Mack Chassis - Anthem (AN) And Pinnacle (PI) - ABS Modulator Wiring Rubbing Front Shock

Some Mack Anthem and Pinnacle trucks built between January 29, 2018 and September 13, 2020, with Hendrickson air ride front suspension may have the ABS modulator valve wiring contact and rub the front shock.

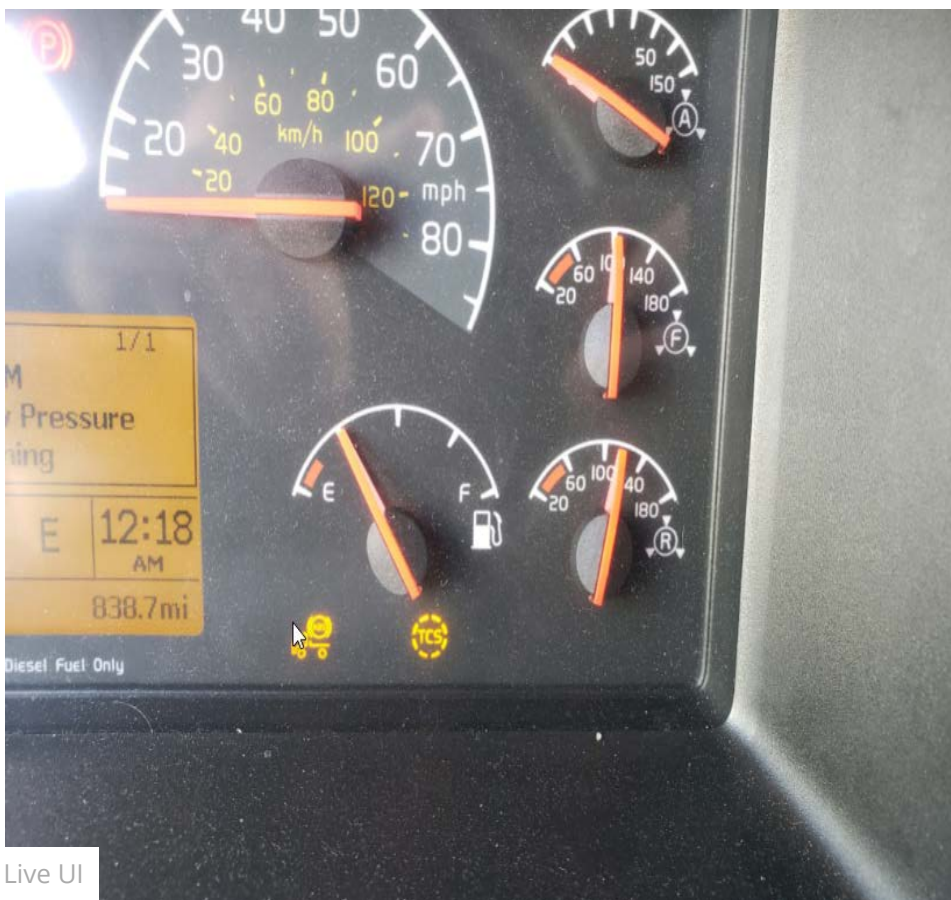
Wire contact and rubbing may result in open- or short-circuits and ABS fault codes. See images below.

A new pigtail connector is available to add clearance between the wiring and shock. Trucks built after September 13, 2020 have the modulator moved rearward away from the shock to prevent contact.

85130746 – Connector pigtail, 4 pin round, twist lock

21105899 – Butt splice for 18 GA/0.8 mm and 1.0 mm wire
